**EXHIBIT A
RECOMMENDED CONDITIONS OF APPROVAL**

**PUD-103
Summerhill Apartment Communities
February 26, 2014**

Original Plan

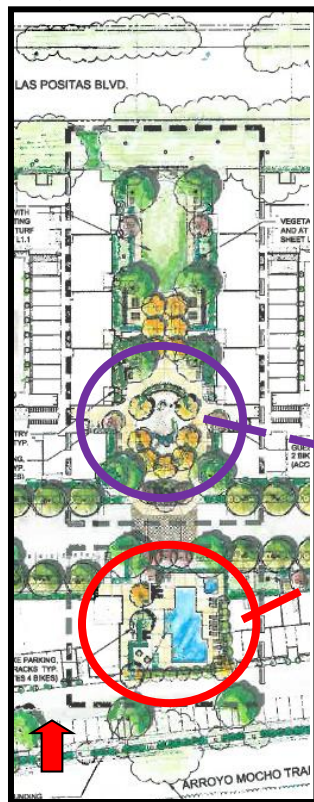
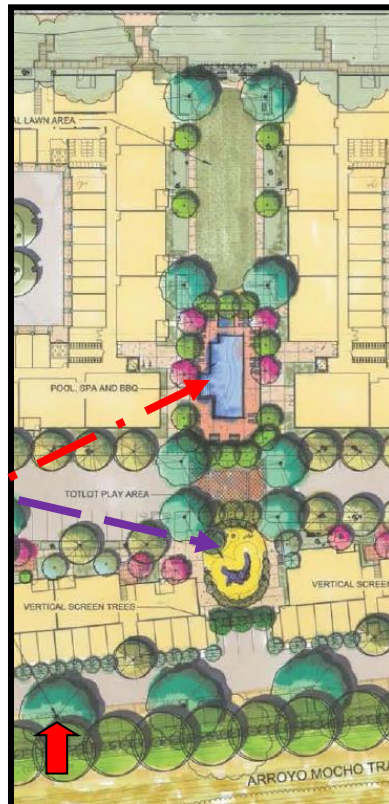
- 1. Site Layout.** In response to Commission’s comments regarding the pool location, size of the common open space area, and size of the tot lot, the applicant has revised the site layout to: 1) relocate the pool to the north between Buildings A and B; 2) relocate the tot lot to the south and reduce its size from 2,400 sq. ft. to 2,080 sq. ft.; and 3) increase the square footage of the common open space area from 2,528 sq. ft. to 4,464 sq. ft. In addition, walkways have been added to connect the sidewalk along W. Las Positas Boulevard to the proposed residential development. In consideration of security of the private open space area, a fence and a gate are proposed at the northern entrance of the open space. Please refer to the exhibits below and the following page for the revisions.

Revised Recreation Facility Locations

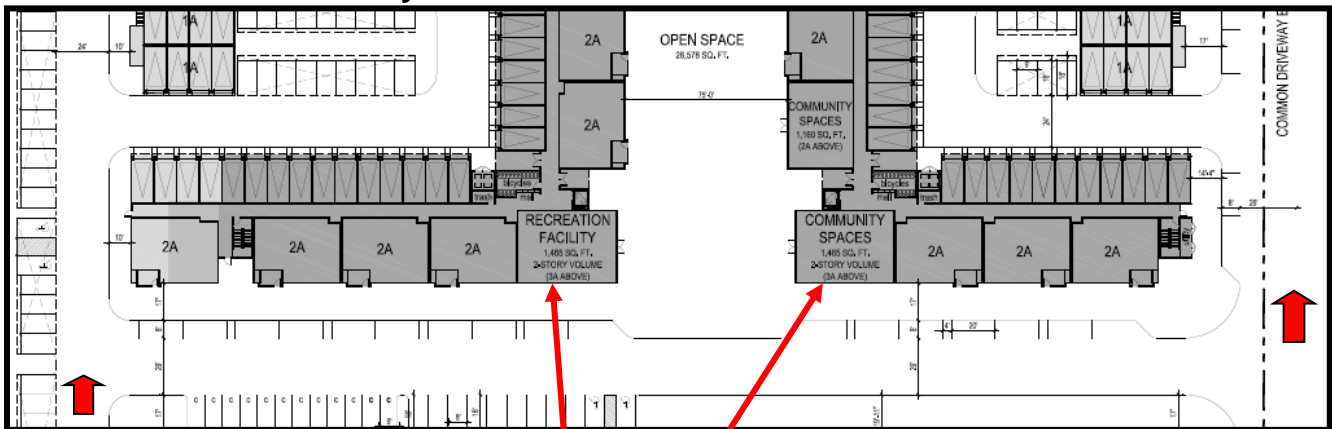
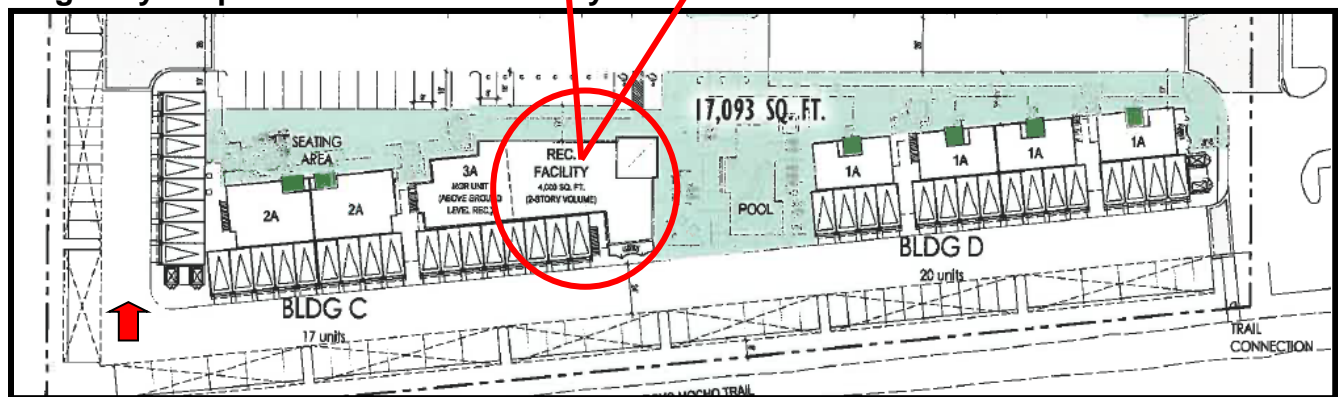
To accommodate to the pool and tot-lot location swap, the applicant has relocated the recreation facility. The recreation facility was originally proposed to be located in the eastern end of Building C. The applicant now proposes to locate the facility in both Buildings A and B. Building A would have the fitness facility and Building B would have a lounge area. Please see exhibits on the following page.

Discussion Point No. 1: Is the new location of the pool and other amenities, and access from W. Las Positas acceptable?

Original Plan

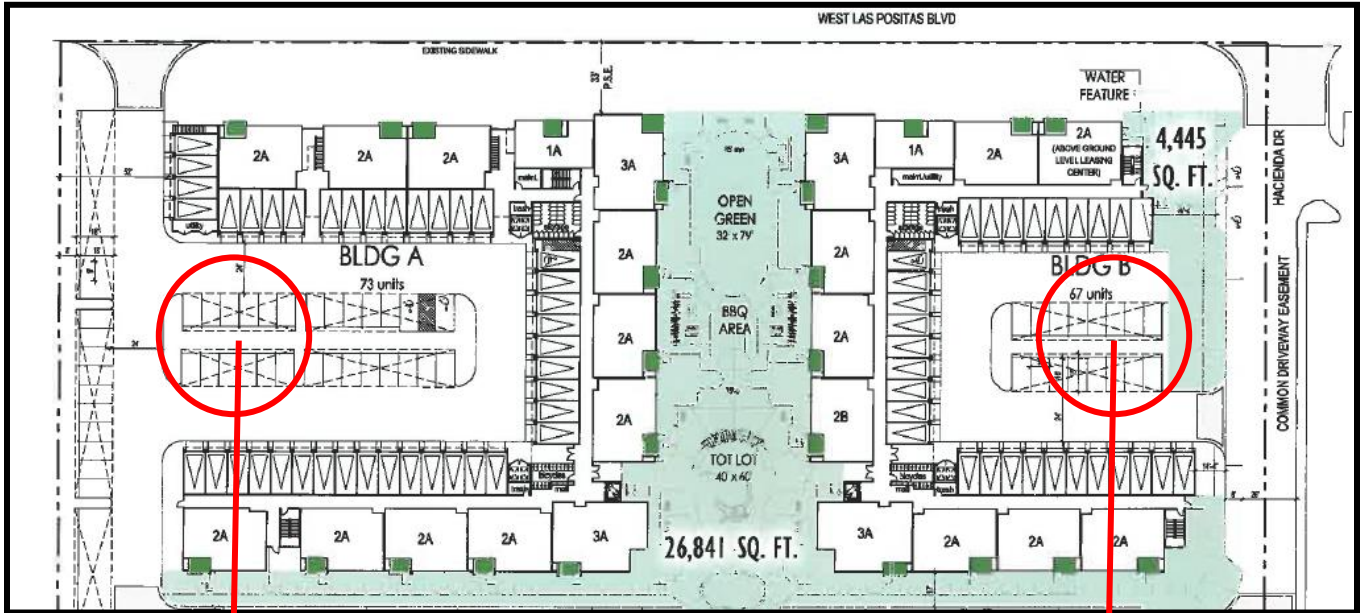
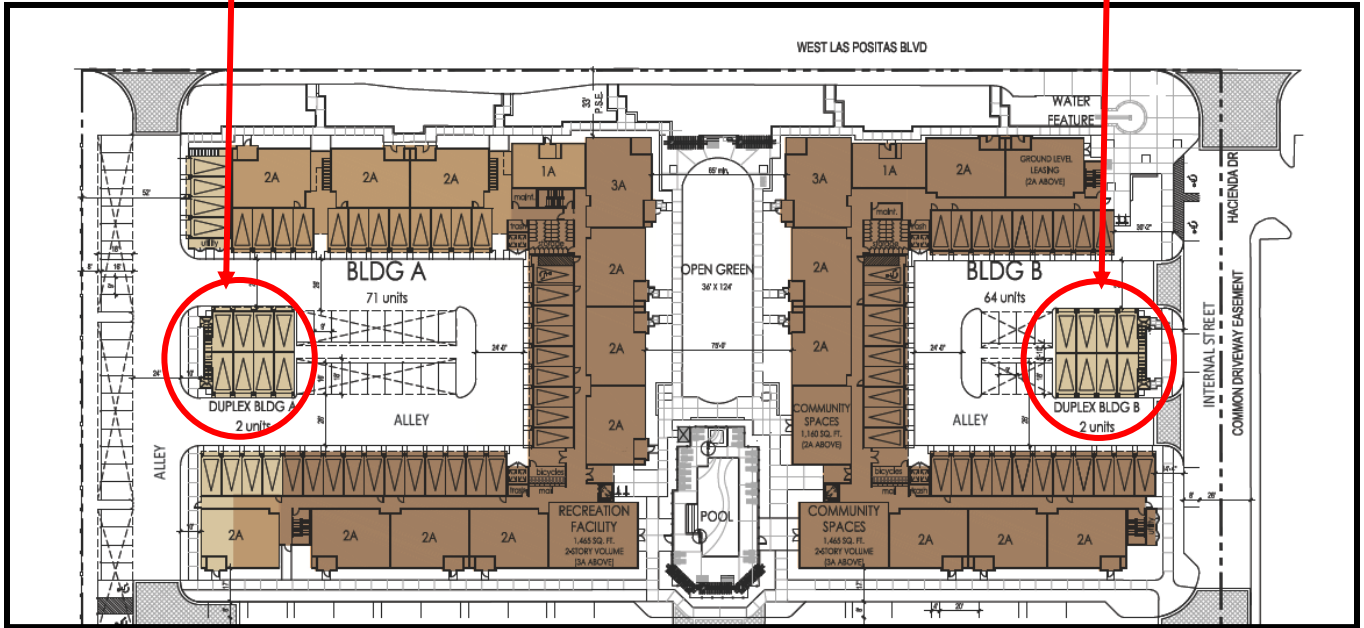
4. Redistribution of Dwelling Units. As a result of lowering the building height of the buildings located in the southern portion of the site (Buildings C and D), the applicant has relocated four units (referred to as duplex units) in the middle of Buildings A and B, changing the middle carport area to a combination of carport and two-story building (one living floor above garage) to meet the required density.

Discussion No. 4: Is the revised dwelling-unit with living units over parking by Buildings A and B acceptable?

Original Plan

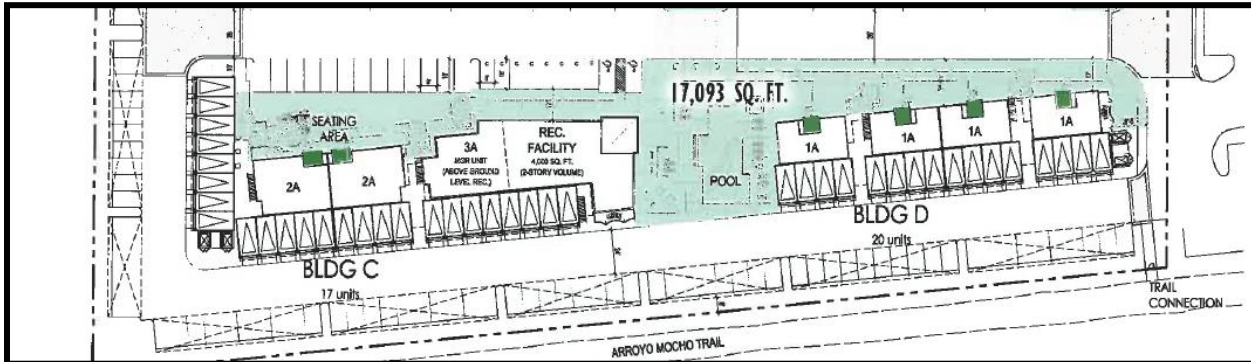
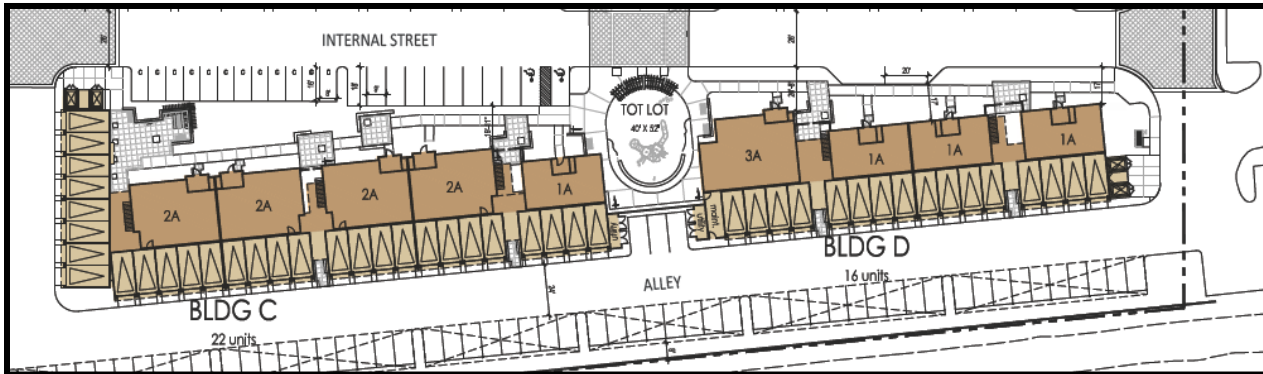
Additionally, the applicant has relocated five dwelling units to Building C and removed four units from Building D.

Planting Growth Photosimulations

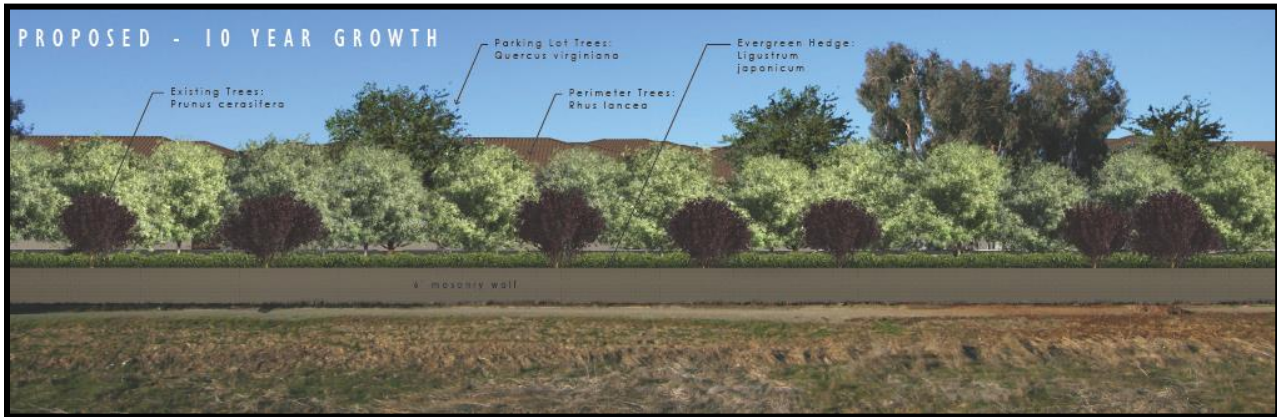
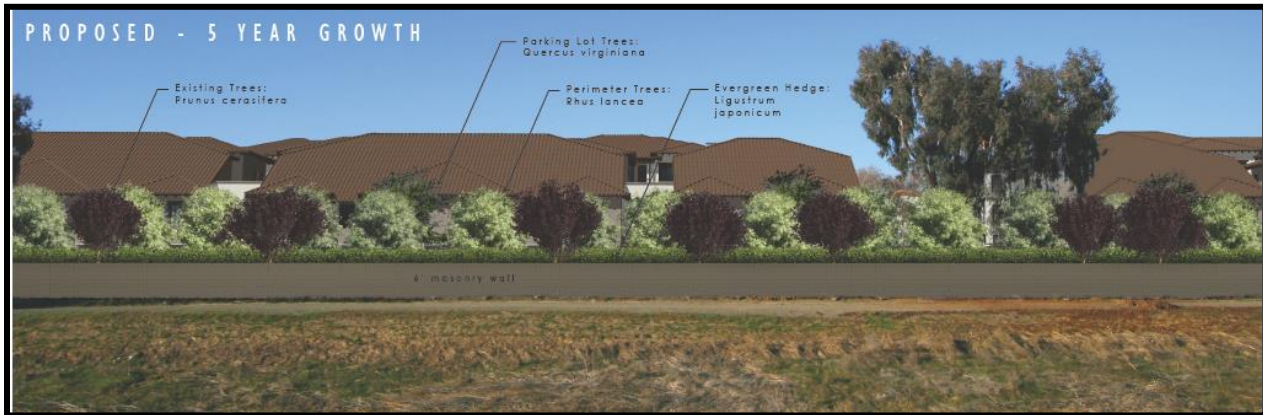
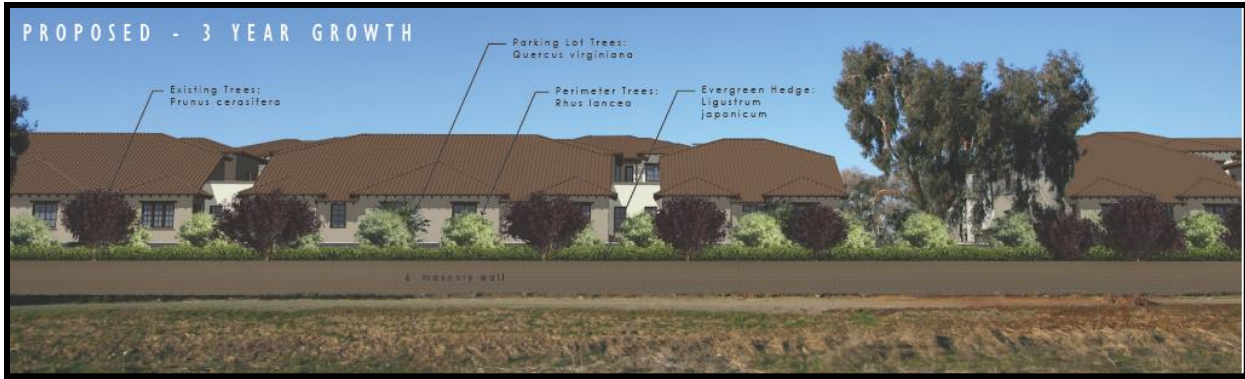
To screen the proposed development from the existing residential neighborhood located to the south, the applicant has revised the landscape plan at the southern property line. The existing trees (seven red ironbarks, 12 plums, and a cork oak) along the southern property line would remain. In a discussion with the project landscape architect, evergreen shrubs and *Rhus lancea* (African Sumac) trees would be planted to screen the future buildings. The evergreen shrubs would be trimmed to form a dense hedge. The applicant prepared photosimulations showing the planting along the southern property line at growth intervals of three, five, and ten years.

Discussion Point No. 6: Is the revised landscaping in the rear acceptable?
